# 1ST & PIKE

103 PIKE STREET

EARLY DESIGN GUIDANCE 3  
03 APRIL 2018  
DPD #3028428

4. EAST FACADE

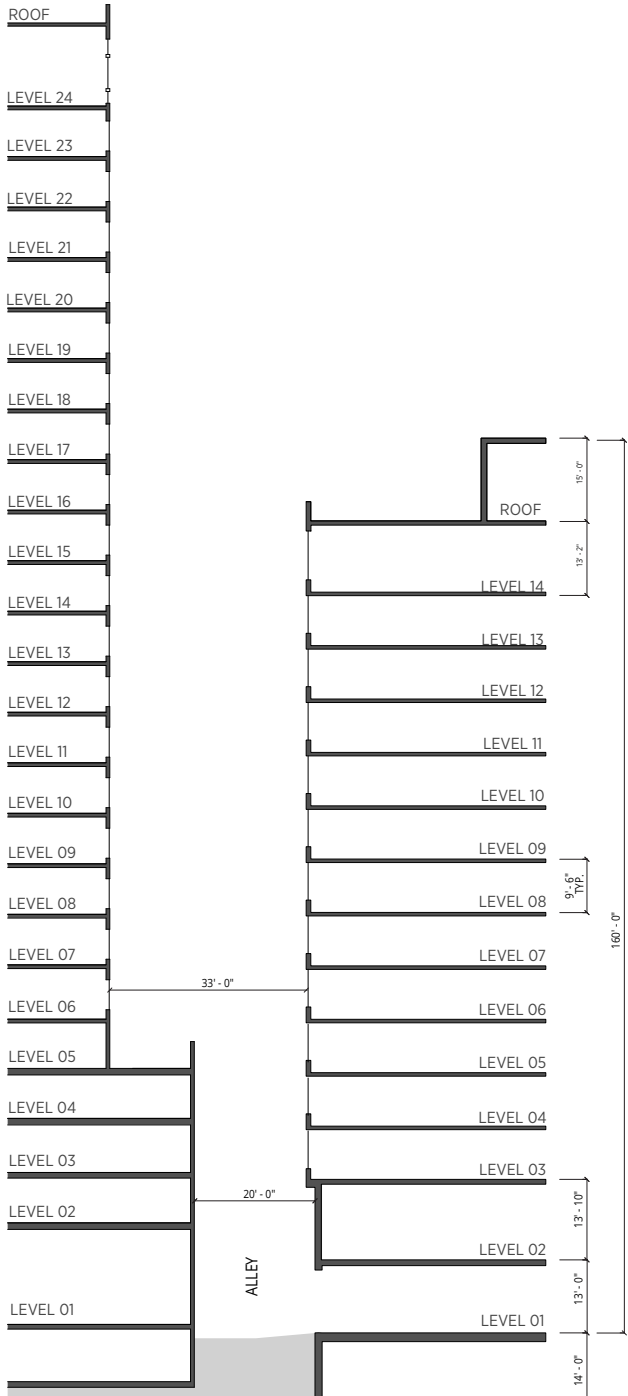
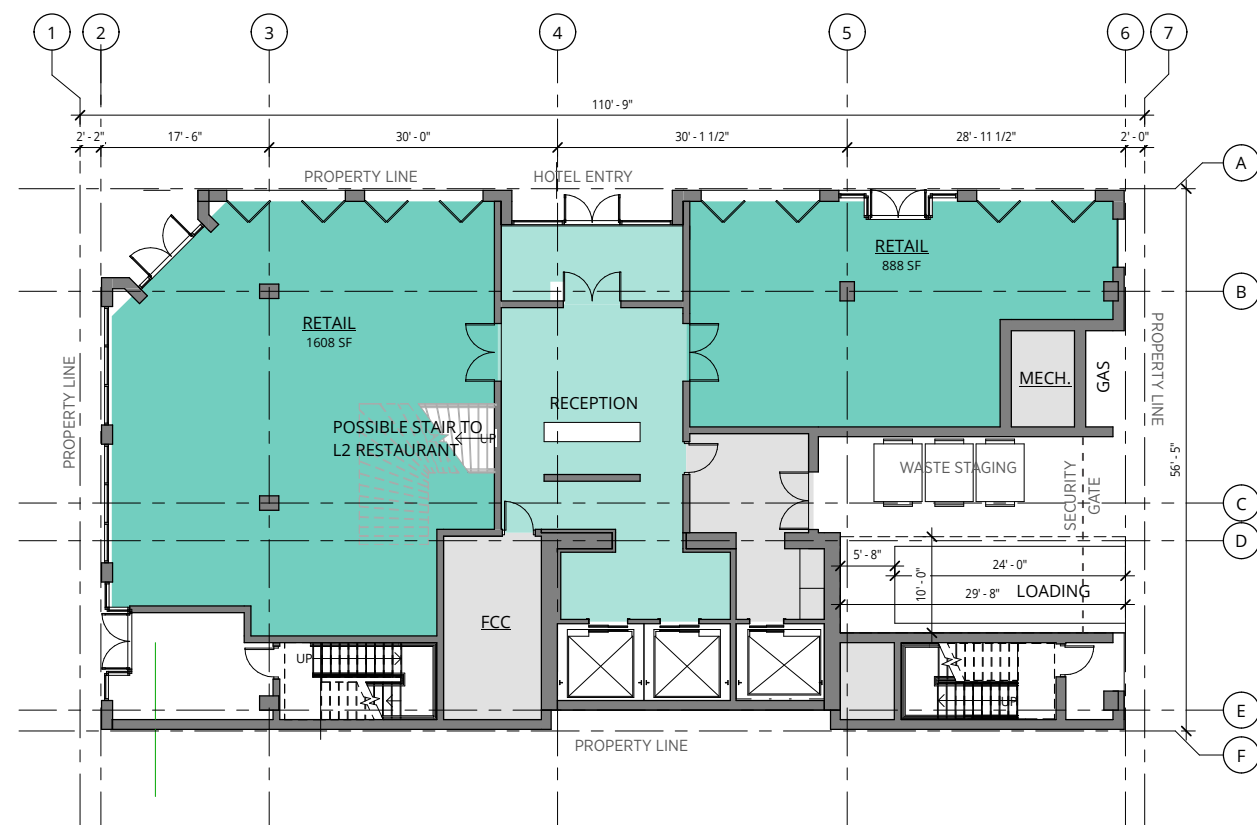
- Carefully consider the design of the east wall facade, do not treat it like a blank party wall;
- Carefully design the south party wall.

Glazing has been added to the east wall facing the alley. Details to further articulate the facade will continue to be developed for Design Review. The south facade party wall may include an artwork feature to connect to the artistic characteristics of the Market.
